Subject: Kern River No. 3 Hydroelectric Project (FERC No. 2290) - 036
Fish Population Monitoring Results

KERN RIVER NO. 3 HYDROELECTRIC PROJECT
FERC NO. 2290-006
FISH POPULATION MONITORING 1998

The Draft Kern River No. 3 Kern River No. 3 Hydroelectric Project FERC No. 2290-006 Fish Population Monitoring 1998 was provided to the California Department of Fish and Game, the U.S. Forest Service Sequoia National Forest, the National Park Service - Sequoia National Park, and the U.S. Fish and Wildlife Service for review during January, 1999. Comments were received from the Forest Service (letter dated March 10, 1999) and the Park Service (letter dated February 22, 1999). These comments are included as Appendix D.

Figure 1-2. Sampling Stations Used for Monitoring Fish Populations in the North Fork Kern River During 1989-1991 Relicensing Studies.

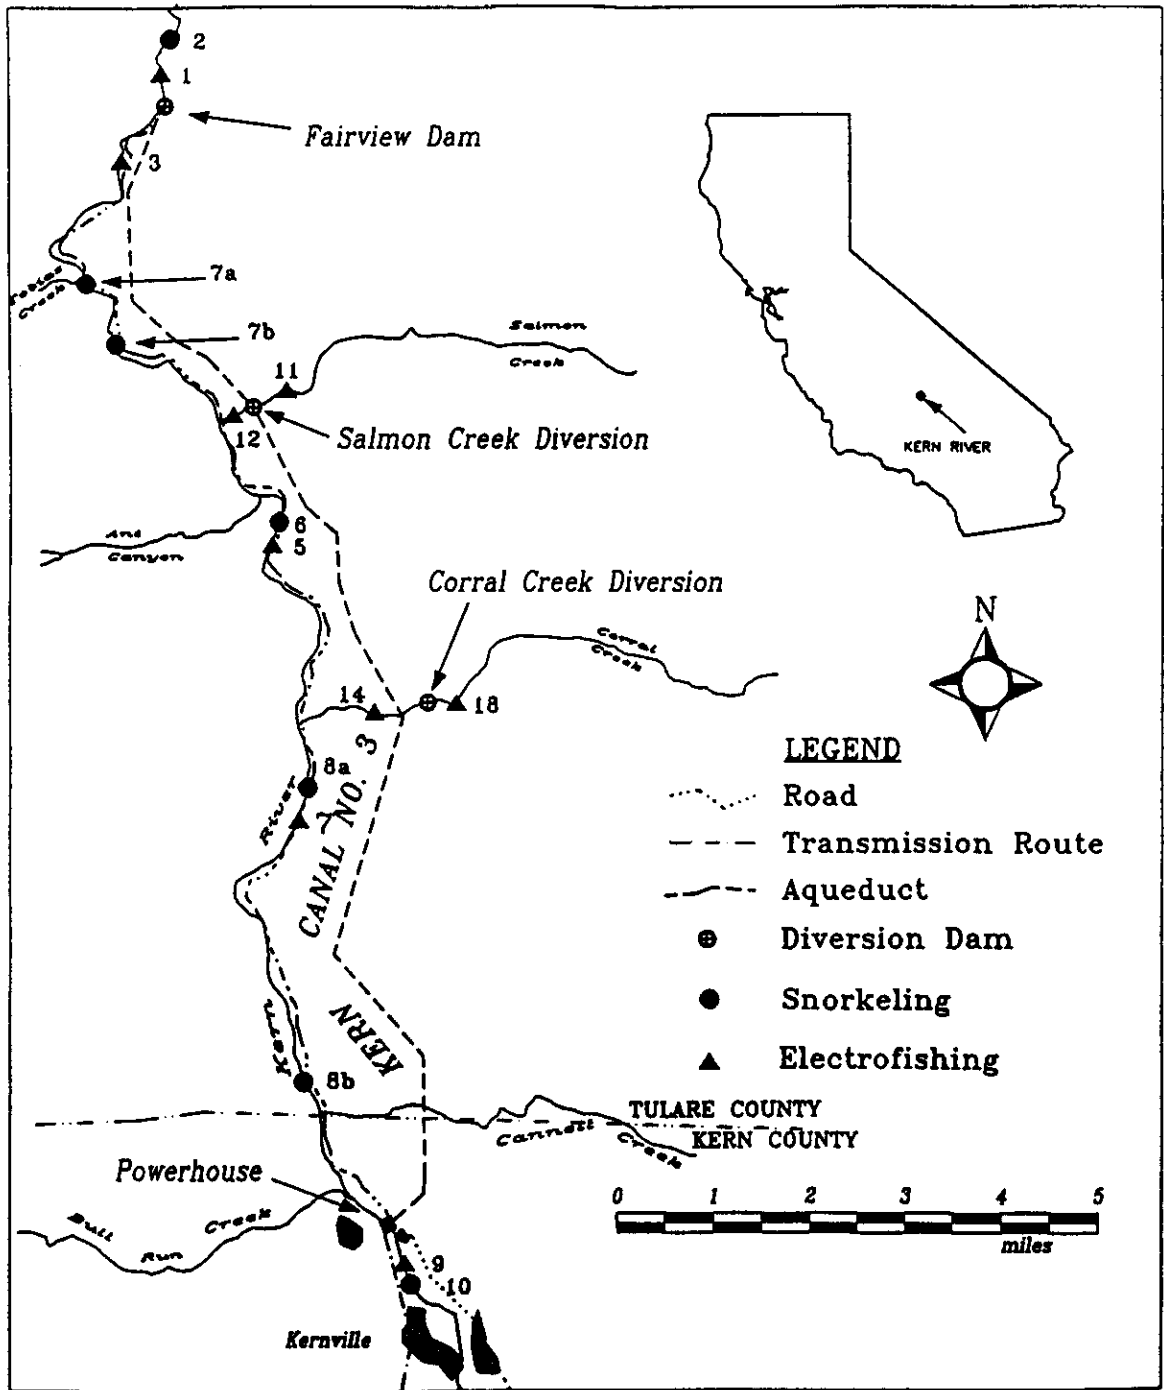
Comment 1: "*The maps on pages 1-4 and 2-2 are confusing.*"

The map on page 1-4 was intended to convey the locations of the study sites used during the relicensing study and was intended to show that the current study site locations are within close proximity to those stations. This map was incorporated from the FERC Exhibit E without modification. The site locations on Page 2-2 will be labeled with the appropriate designations as included in the text of the report.

Figure 2-2. Photographs of Fish Monitoring Stations

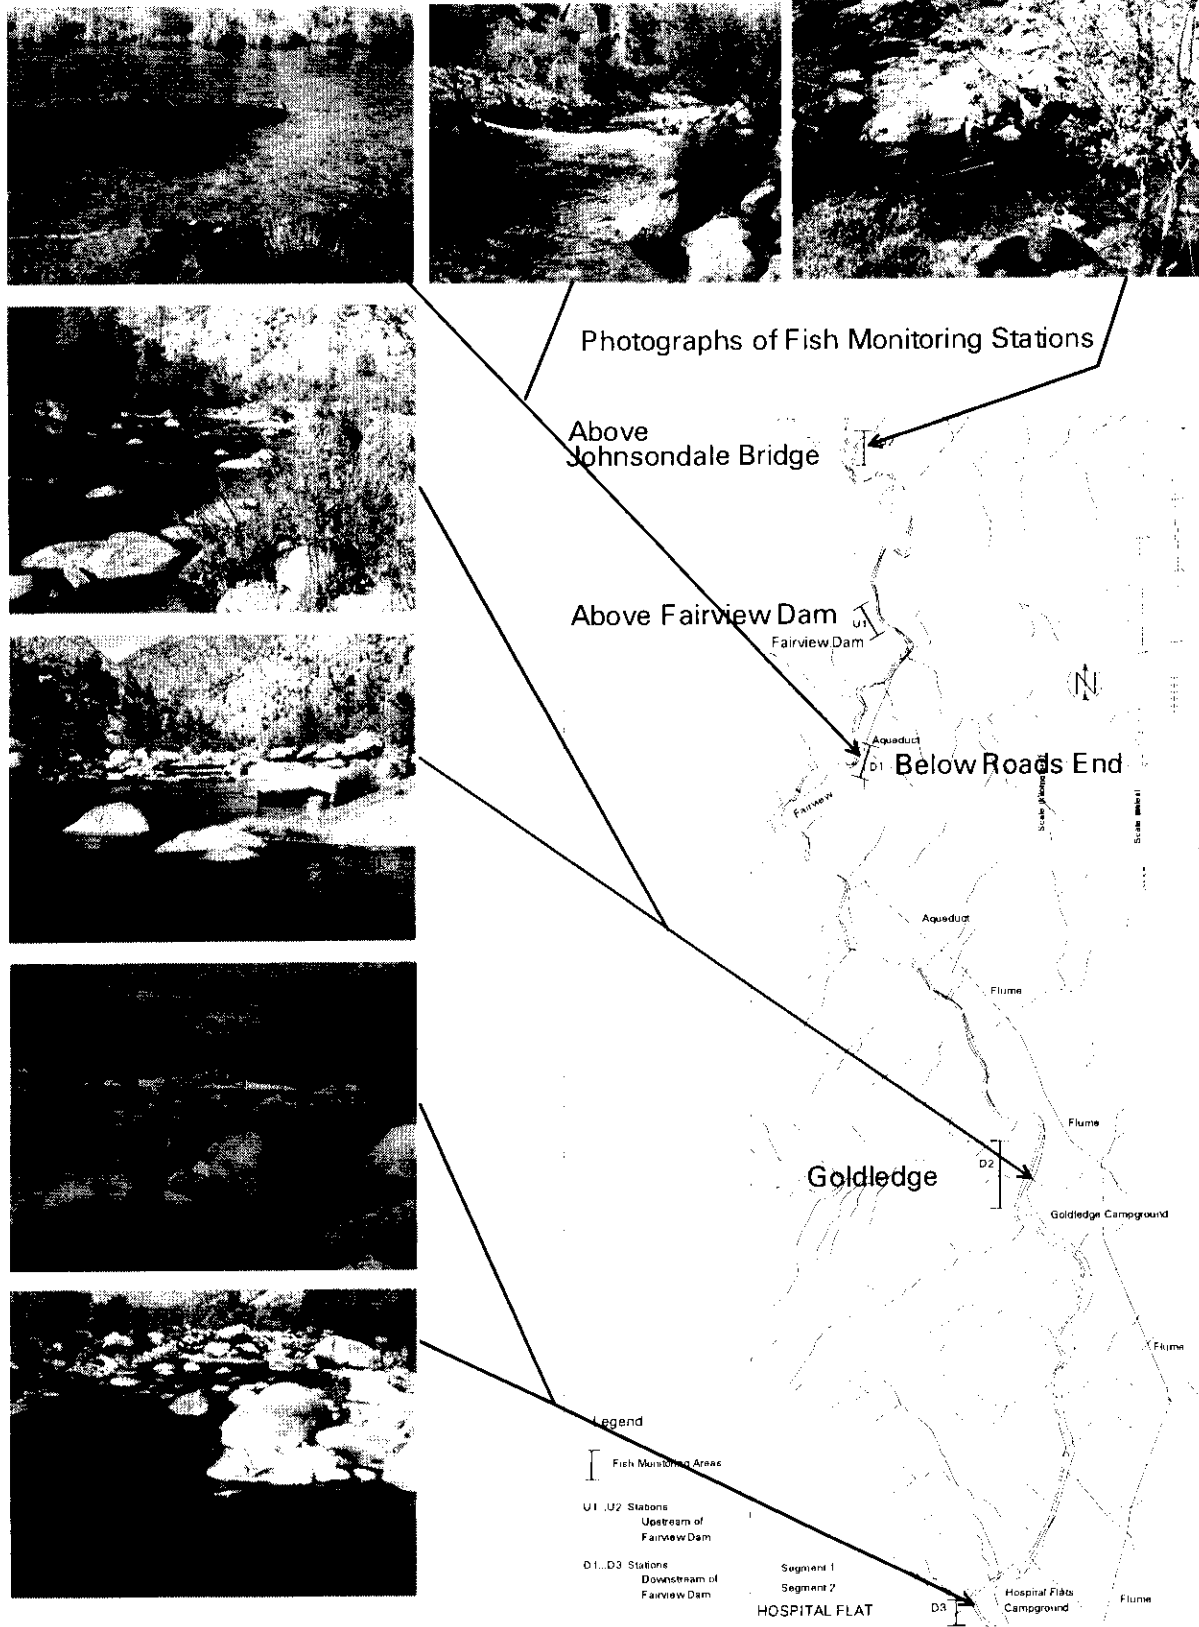
Comment 2: "*Photographs of the sampling sites would be a very nice addition to the report for people who are not familiar with the area.*"

We agree and have incorporated available site photos in Figure 2-2.
